**Proposal for draft amendments to Regulation No. 12,14, 16, 17, 21, 25, 94, 95 + other
Regulations managed by other GRs
(Corrigendum)**

ECE 14

ANNEX 4 – APPENDIX 1
DESCRIPTION OF THE THREE DIMENSIONAL "H" POINT MACHINE (*)

Figure 2: Dimensions of the 3-D H machine elements and load distribution
a excludes H-point buttons

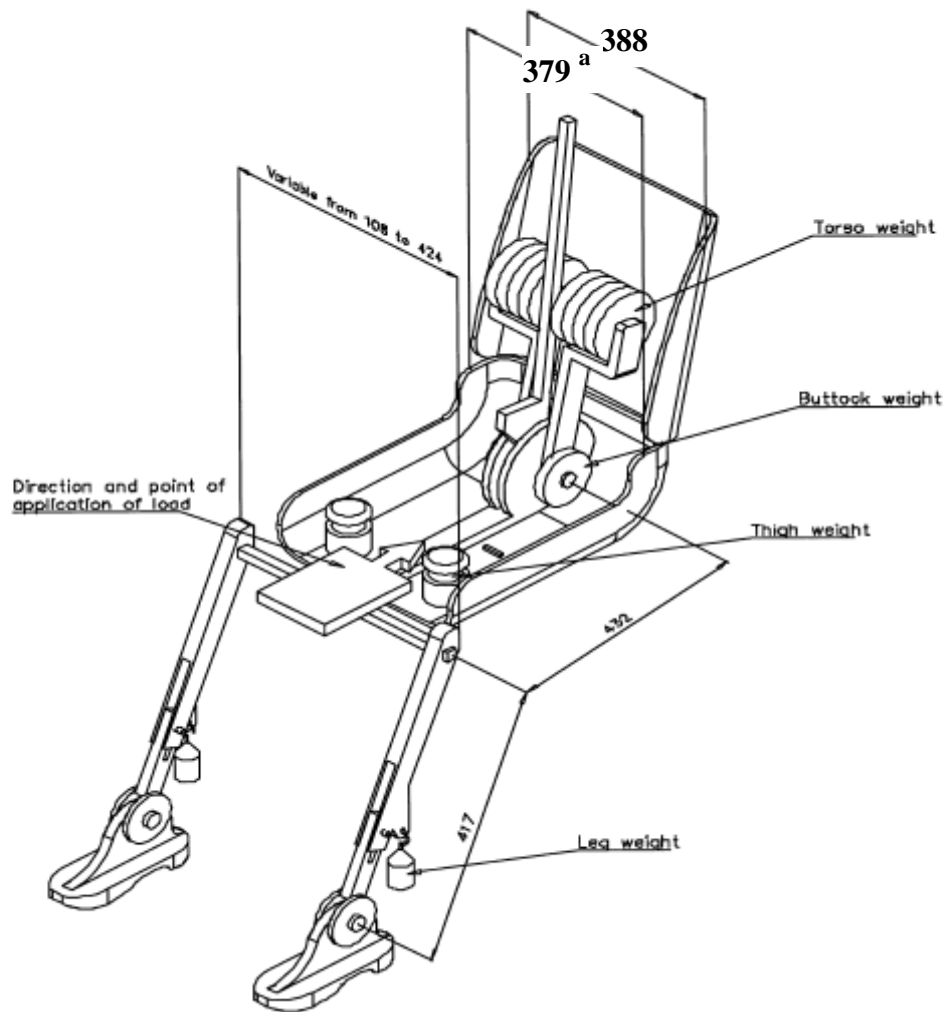
Since 1989 all H-point measurement devices produced by SAE have a back width of 388mm and cushion width of 379mm instead of 395mm and 385mm respectively. This clarification has been introduced into ISO 6459:1999. It is also mentioned in SAE J826 – nov 2008. The difference has a minor influence to the measurement of the torso angle and H-point in comparison to the allowed tolerances. But those small influences in H-point and torso angle will be significant for the backset measurement of ECE 17 series 09 and only dummies compliant to actual SAE builds shall be used for backset measurement.
